MATERIAL INSPECTION REQUEST (MIR) FORM

Contractor:	HAIF COMPANY
Project:	QPMO-410-CT-00618- ROAD ACCESS TO RESORT CORE
Contract No.:	QI09043311-VO-0004
Material Inspection Request Number:	QRXM114000-HFC-TEC-MIR-ITS-02-RO5-00020

Project Name: Package 3 - **Interim Road Access to Resort Core**	**Project Code:** QRXM114000
Location: 00	**Date:**22-January-2026
Document Title:**Material Approval Request FOR ITS SYSTEM SUPPLYING & INSTALLING BY TRAFFIC TECH SECURITY W.L.L** (ITS and CCTV Poles)	**Ref No:** QRXM114000-HFC-TEC-MAT-ITS-02-RO5-00017
	Rev No: 00

Document Description:Material Approval Request FOR ITS SYSTEM SUPPLYING & INSTALLING BY TRAFFIC TECH SECURITY W.L.L (ITS and CCTV Poles)

Drawing title: SHOPDRAWING OF TRAFFIC SIGNAL SYSTEM FOR JUNCTION-2
TYPICAL ITS POLE DETAILS - 6.1M

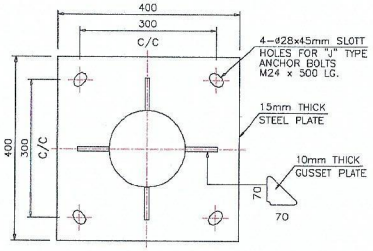
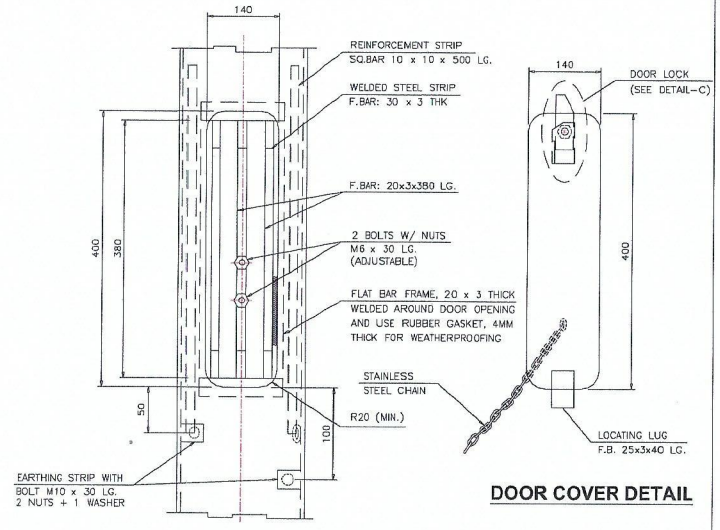
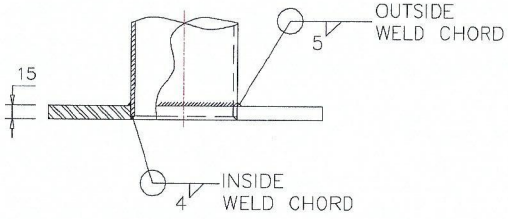
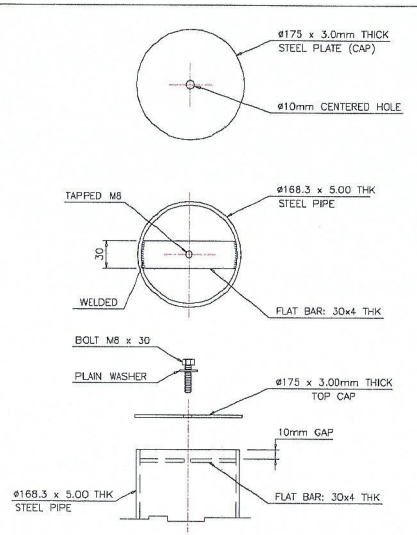
1. ITS poles shall be in accordance with the poles manufacturer's recommendations.
2. Galvanization & Compliance certificates with the standards to be provided
3. For other comments refer to drawing #QRXM114000-HFC-DRW-SDW-ITS-02-R05-00024

ITS POLE - 6.1M

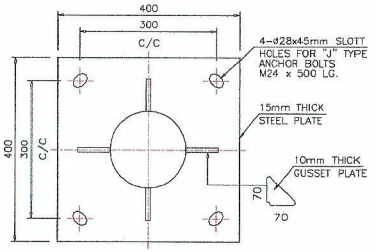
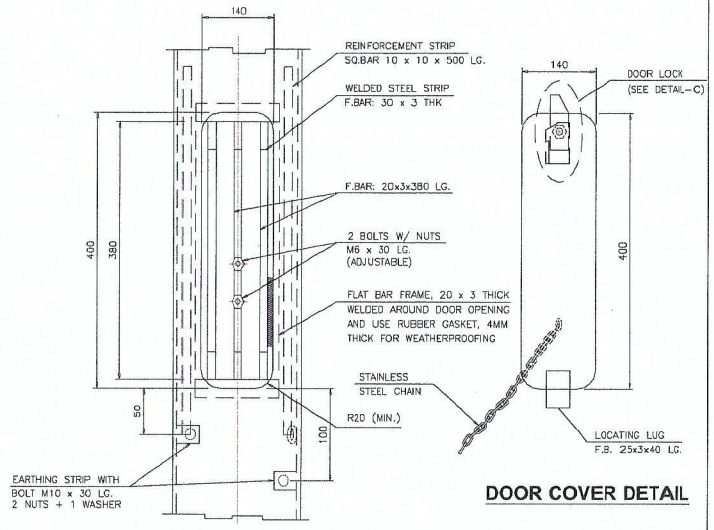
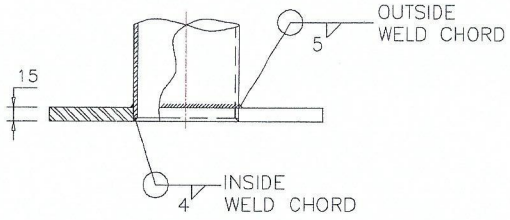
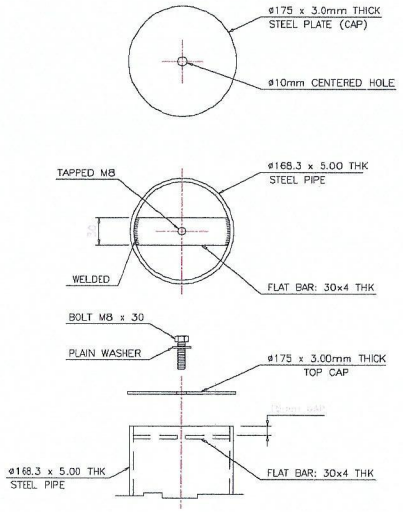
1.ITS poles shall be in accordance with the pole manufacturer's recommendations.
2. Galvanization & Compliance certificates with the standards to be provided
3. For other comments refer to drawing #QRXM114000-HFC-DRW-SDW-ITS-02-ROS-00015

Drawing title:
SHOPDRAWING OF TRAFFIC SIGNAL SYSTEM FOR JUNCTION-1
TYPICAL ITS POLE DETAILS - 15M

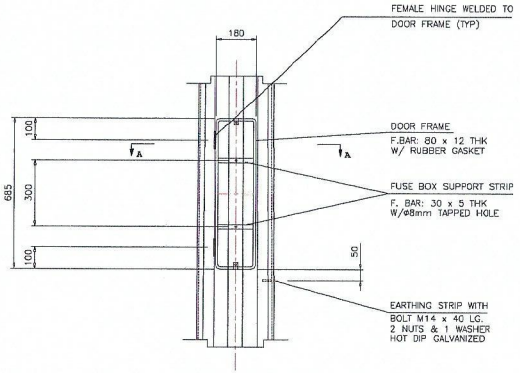
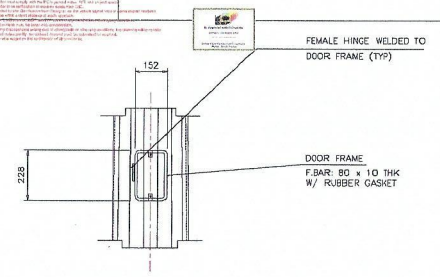
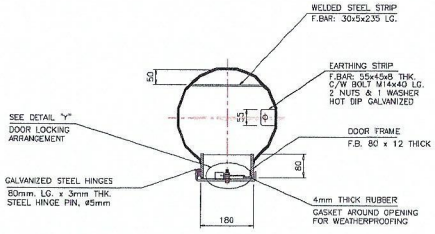
1.ITS poles shall be in accordance with the pole manufacturer's recommendations.
2. Submmission & Compliance certificates with the standard to be provided
3. For other commentes refer to drawing #QRXM114XX-HFC-DRW-SDW-ITS-02-R05-00055
